Residue Upgradation Facility (RUF) EPCC-3 Package for Visakh Refinery Modernization Project (VRMP)	 L&T Hydrocarbon Engineering
		L&T-CHIYODALIMITED
Title: Process Datasheet for CLOSED BLOWDOWN DRUM-2 (504-V-809) Doc. No.: B016-RUF-LT-504-PC-DS-0290		Rev. No.: 0 Page No: 1 of 2

EQUIPMENT NUMBER: 504-V-809
 EQUIPMENT NAME: CLOSED BLOWDOWN DRUM 2

ANNEXURE – 1**CHANGE LIST**

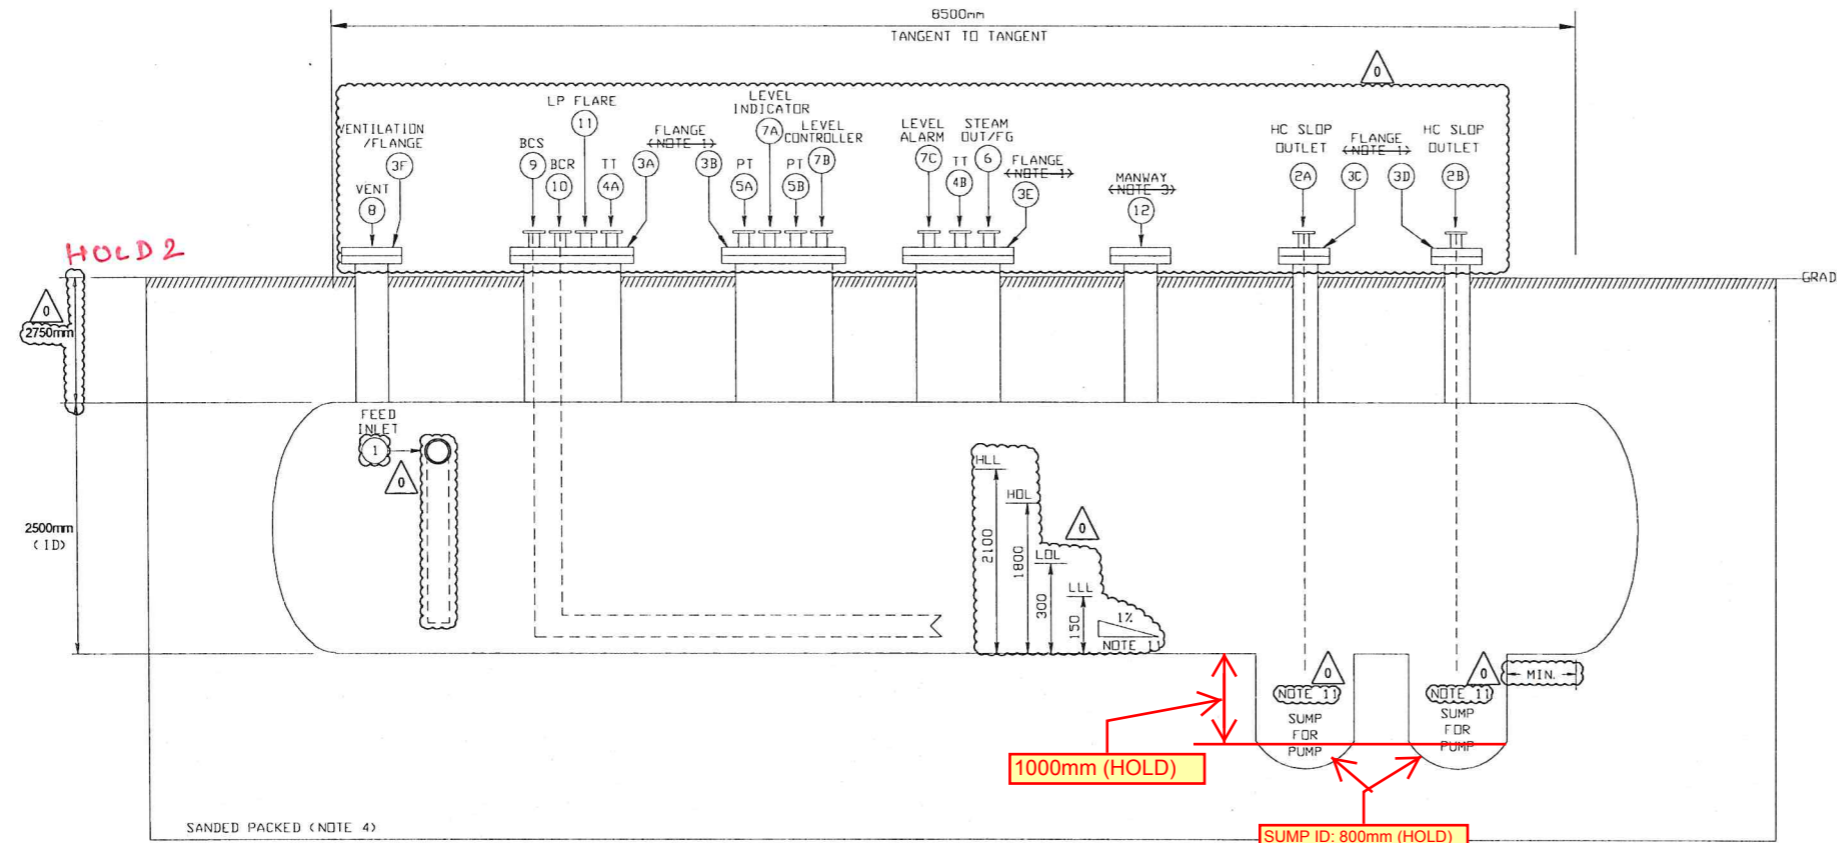
Sr. No.	Page No.	Description of change	Reference / Remarks
1.	2	Flanges numbers revised & sizes are defined in nozzle details & corresponding Note 1 is updated.	As per flange design input by Mechanical department. For detail refer mechanical engineering drawing. Number of flanges and detail will be updated in Rev 1 of P&ID: B016-RUF-LT-PID-504-11812A.

2.	2	Nozzle numbers are defined on vessel sketch.	For better clarity on nozzle identification. It will be updated in revision 1 of P&ID: B016-RUF-LT-PID-504-11812A.

3.	2	Vent nozzle #8 & steam out nozzle #6 sizes are defined as 2” each as vessel is non-cladded, in nozzle details & corresponding Note 2 is updated.	Reference to EIL BEDB Part B clause 8.5.3.3 (“A758-999-02-41-ODB-1001” pg. 73 of 115).

4.	2	Manway nozzle #12, location and size (24”) is confirmed & corresponding Note 3 is deleted.	1. Manway location is at top of shell of horizontal vessel. Final location will be decided by Mechanical engineering based on piping. There is no other Process engineering input required. 2. Manway size is defined based on EIL BEDB (Part-B) clause 8.5.3.3 A758-999-02-41-ODB-1001 pg. 73 of 115.

Sr. No.	Page No.	Description of change	Reference / Remarks
5.	2	Drum location w.r.t ground level is defined on vessel sketch and corresponding Note 4 is modified.	Relative elevation of drum is provided as per piping input considering slope of feed inlet blow down header to the vessel.

6.	2	Feed nozzle (#1) size changed from 6" to 10" and update the nozzle location.	<p>As per clause C-123 of Annexure A of "C-1.3B016-79-41-EPC-107 Rev-4" page 61 of 66 and consistent with P&ID: B016-RUF-LT-PID-504-11812 (Rev 0).</p> <p>The feed nozzle was fouling with knuckle of vessels while placing it above HLL. Hence, the feed nozzle was shifted to shell as marked based on input by Mechanical department.</p>

7.	2	Level tap nozzle#7(A-C) sizes are defined as 4" for radar type.	As per Instrument design basis & EIL guidelines in doc. no. B016-504-16-EDB-95097-52-0001.

8.	2	Ventilation nozzle defined separately and update to Ventilation/Flange (#3F)	As per mechanical department input, Ventilation nozzle is considered as flange. For further details, please refer Mechanical Engineering Drawing.

9.	2	Cooling water supply and cooling water return word is changed to Bearing cooling water supply (#9) and Bearing cooling water return (#10) respectively in nozzle detail table. Also corresponding changes made in sketch and note 5 i.e. CWS and CWR changed to BCS and BCR.	To keep it in-line with P&ID: B016-RUF-LT-PID-504-11812 (Rev 0).

10.	2	Liquid level nomenclature is modified on vessel sketch for better clarity on level identification.	As per EIL guidelines in BEDB (Part-B) Abbreviations on pg. 11 of 115 A758-999-02-41-ODB-1001.

11.	2	High Liquid Level (HLL) is revised from 2200mm to 2100mm. Low liquid level (LLL) is	To place the Feed nozzle above HLL, the HLL was reduced. The total pumpable volume between HLL and LLL is ensured as 40 m ³ as specified

Sr. No.	Page No.	Description of change	Reference / Remarks
		defined as 150 mm.	in EIL BEDB (Part-B) clause 6.8.2 pg. 44 of 115 A758-999-02-41-ODB-1001. For detail calculations, please refer Annexure 2.

12.	2	Slope is defined as 1% inside vessel and corresponding Note 11 is added.	To drain towards sumps as per good engineering practice. It will be updated in Rev 1 of P&ID: B016-RUF-LT-PID-504-11812A.

13.	2	Sump and pump discharge nozzle location is changed in vessel sketch and corresponding Note 11 is added.	Location of sumps is towards sloping end of vessel and minimum from TL. Location is changed in order to ensure complete draining of vessel due to slope.

14.	2	Sanded Packed Note 3 changed to Note 4 in vessel sketch.	To provide correct reference of Note 4.
15.	2	Trim added as Note 9.	As per PMS of inlet and outlet lines indicated in P&ID : B016-RUF-LT-PID-504-11812A (Rev 0).

16.	2	MDMT of 12.5 °C added in Note 10.	As per EIL guidelines in BEDB (Part-B) clause 4.2 pg. 22 of 115 A758-999-02-41-ODB-1001.
